MEMO

To: David Wordsworth – Development Control Officer
From: Mark Drust – Public Open Space Co-ordinator Tel:(01724) 297852
Date: 27th March 2008
My Ref: B1 - 12

Re: (PA/2008/0348) & (PA/2008/0349) Permission to construct sports academy, tennis hall & ancillary works including car parking, vehicular access & highway infrastructure, associated landscaping and erection of maintenance depot, café pavilion and play equipment on Land at Central Park, Ashby Road, Scunthorpe

PLAN 3

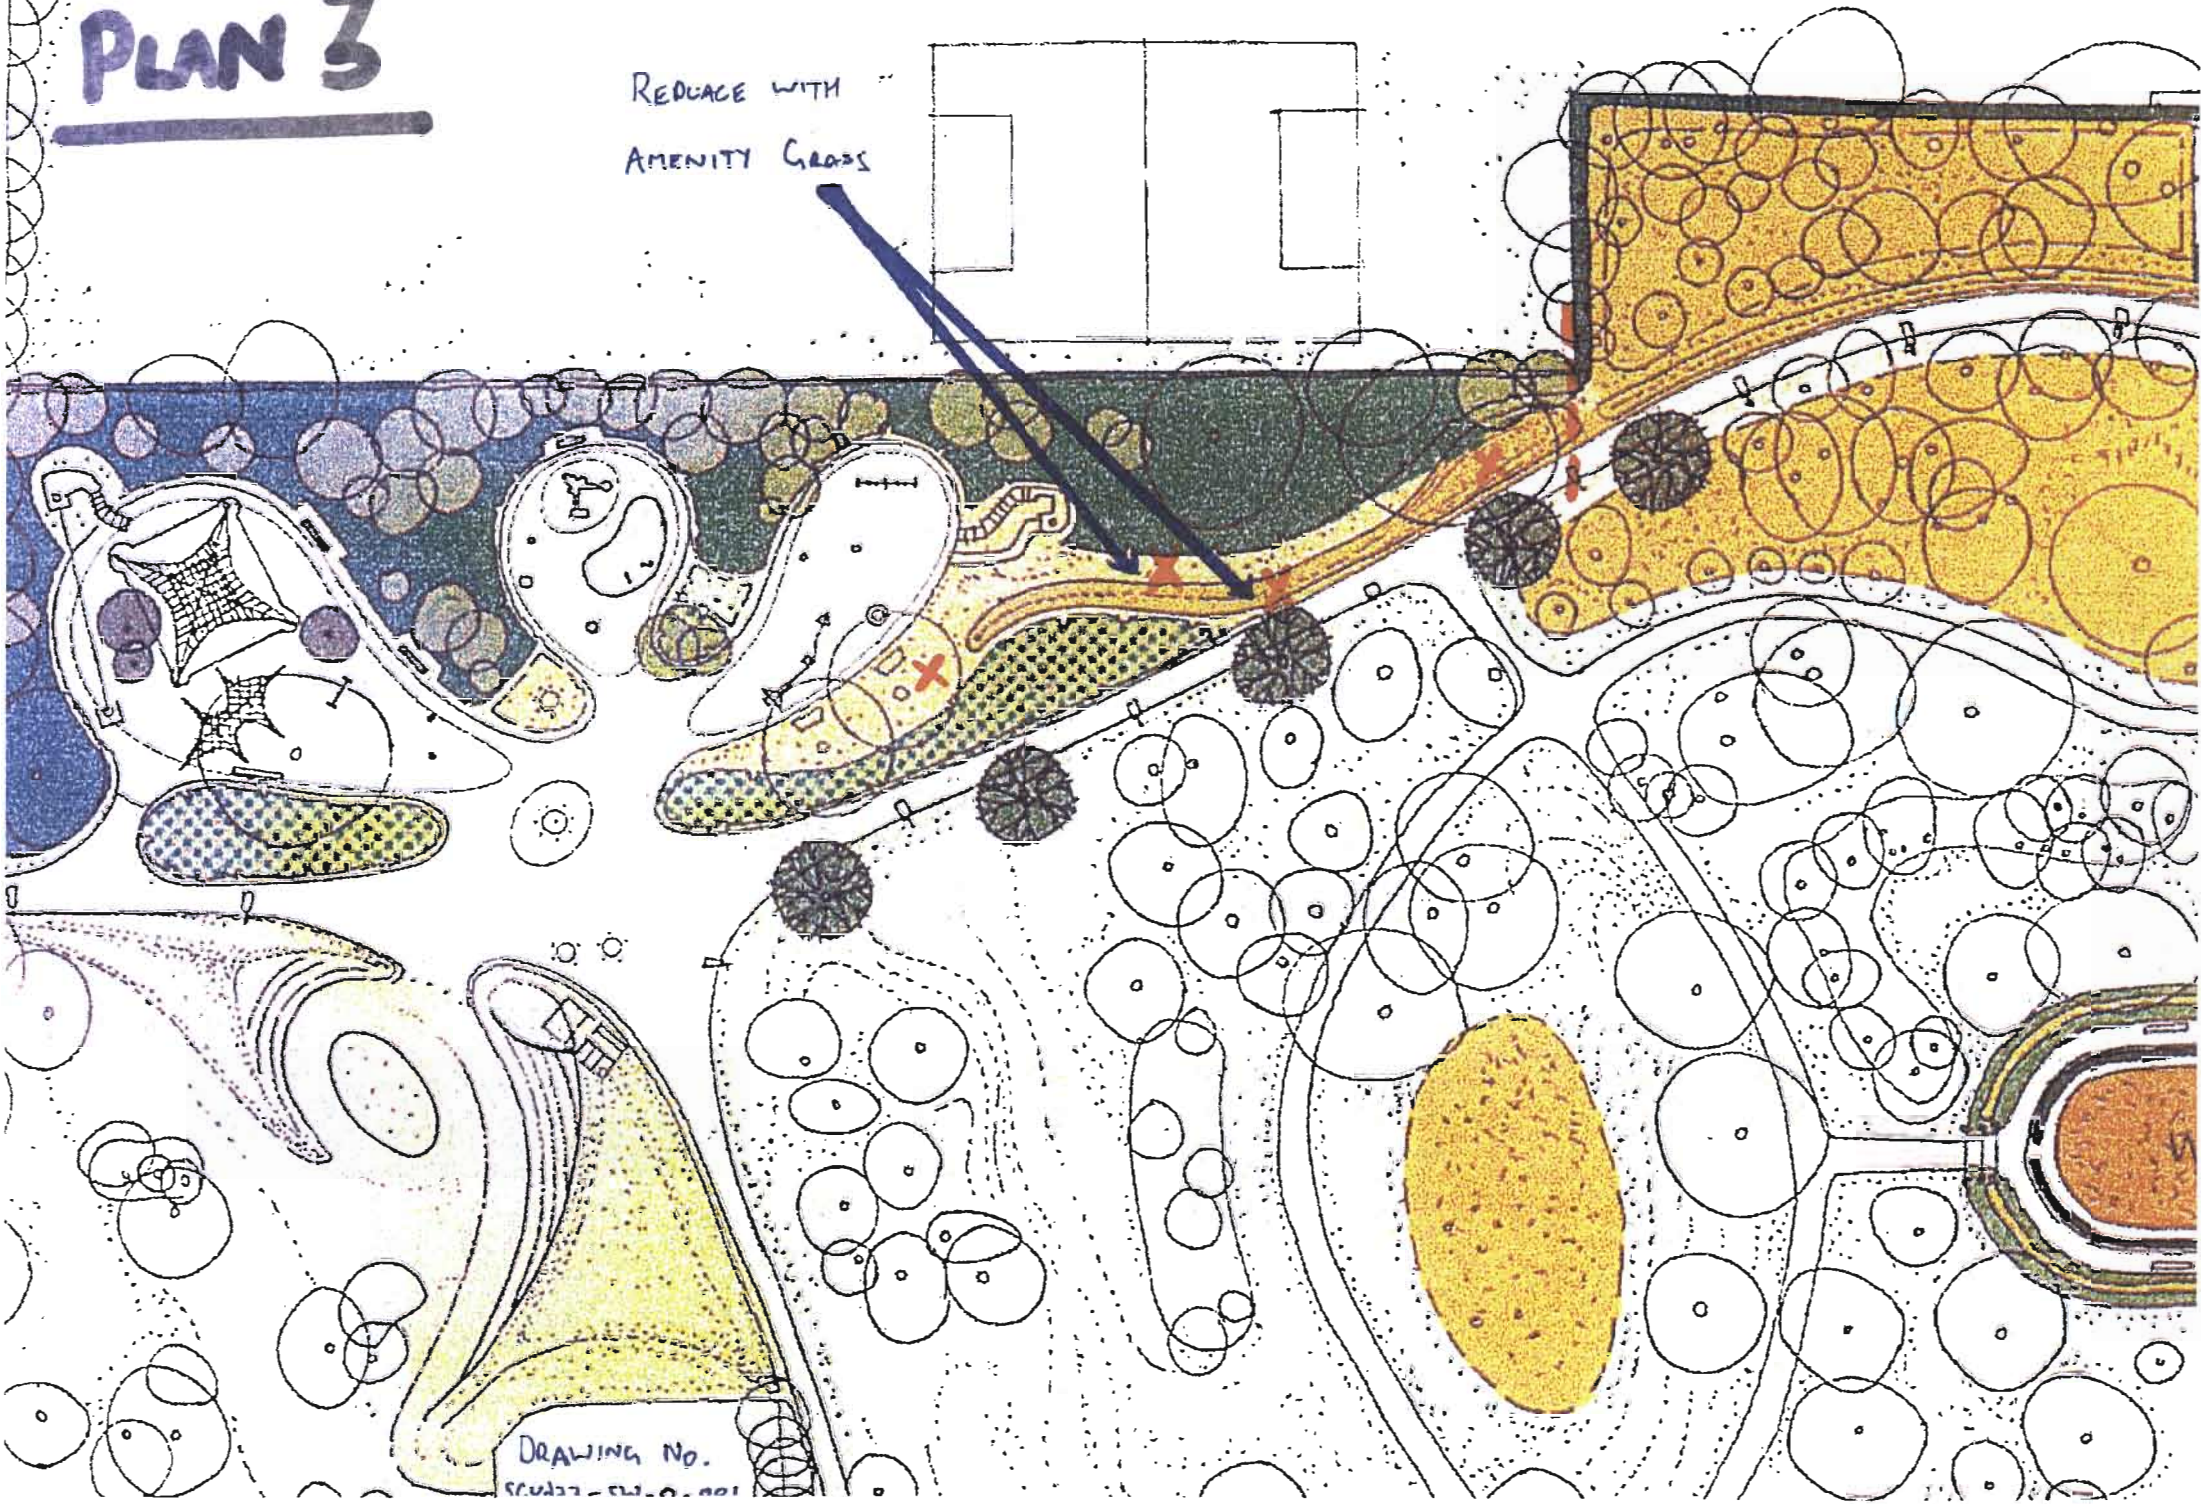
We would like to see the proposed White Clover and Daisy meadow planting close to NEAP B planted as amenity high grass instead to allow for some recreational informal play within this area (please see plan 3). These daisy/clover meadows can hide foreign objects and will obstruct views onto the area if allowed to grow too long. We would also want to see some of the wildflower planting in this area be designated for grass play space (again please see plan 3 for this area). The small area designated as white clover and daisy meadow between the NEAP A and the LAP on the corner we feel is ample enough space of this type of planting for children to enjoy sensory play and well being.

REDUCE WITH
AMENITY GRASS

PLAN 4

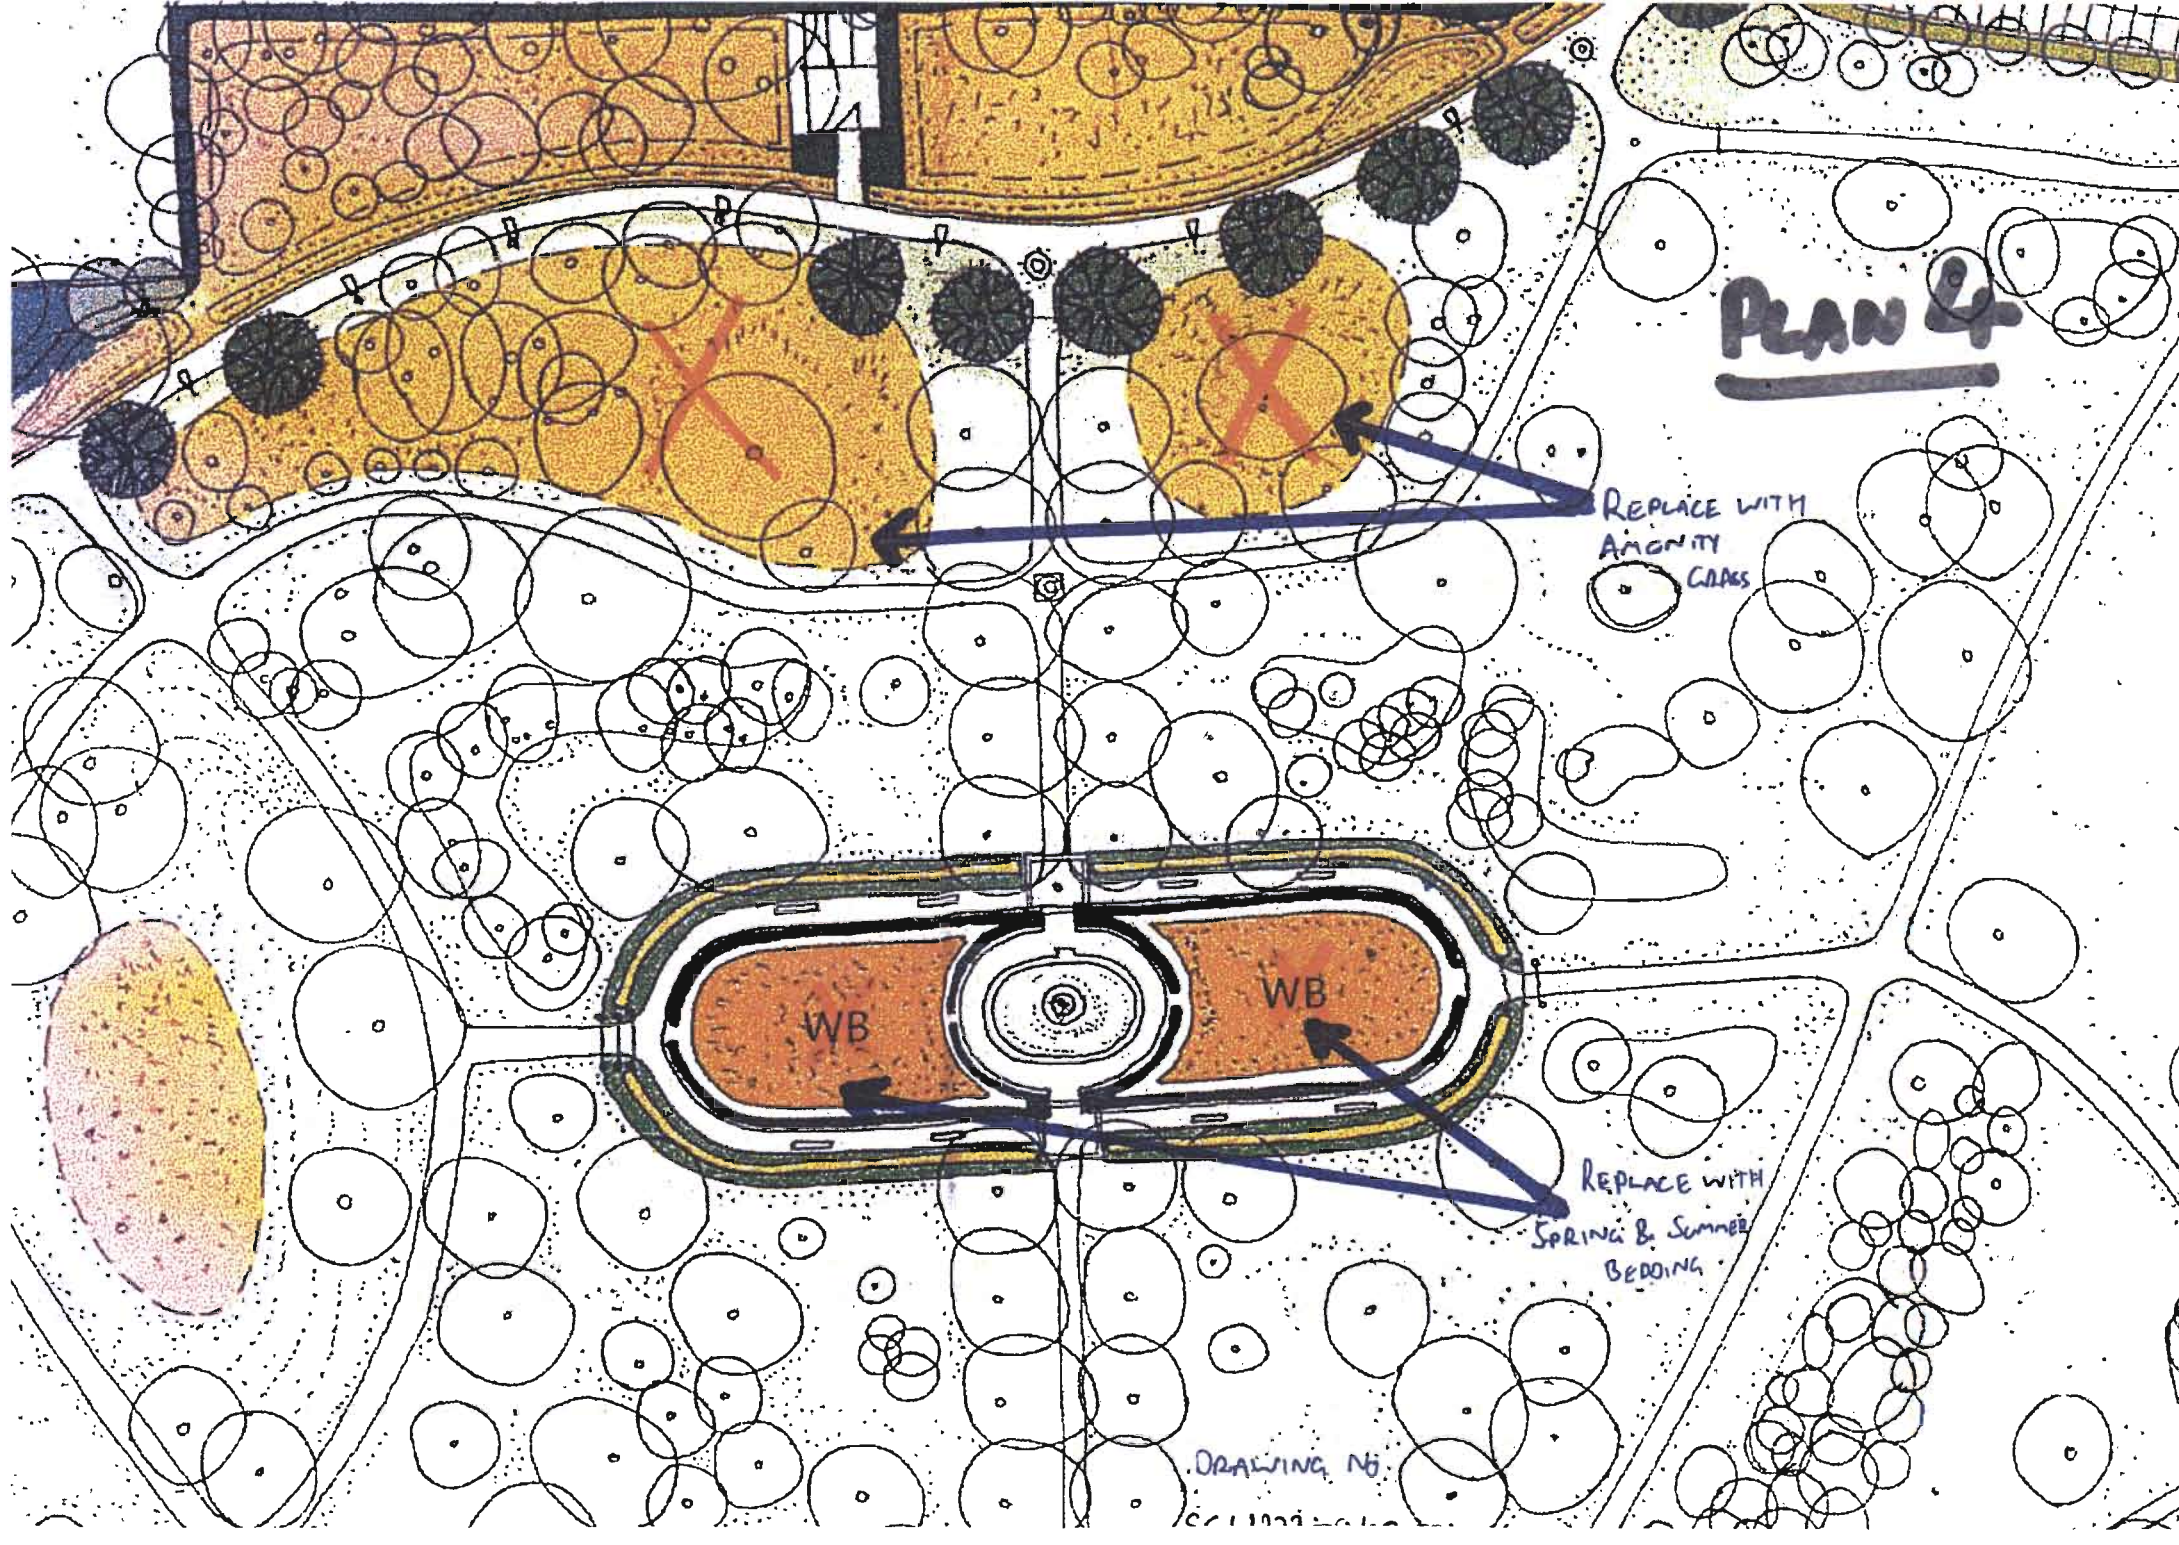
The low maintenance Wildflower & Bulbs Steppes style planting sensory garden we feel should be replaced with formal Spring & Summer Bedding which will offer colour for most of the year as opposed to wildflower which is selective and seasonal in flowering. We also feel that the excessive seed that the wildflowers produce may affect the Water Fountain water quality, as it will be blown into it, blocking filters, restricting flow and making it look unsightly. We are satisfied with the removal of the Hornbeam Hedge as it will only act to obstruct view to the water fountain and the proposed Clipped Box Edging will define the planted beds sufficiently.

We wish to see the following areas shown on plan 4 not as wildflower planting but as amenity grass areas instead for easier maintenance and informal recreational activities. We feel that because these areas are not contained they may spread excess self-setting seed and encroach on to other planted areas. This would greatly increase maintenance costs and labour.

REPLACE WITH
AMENITY
COATS
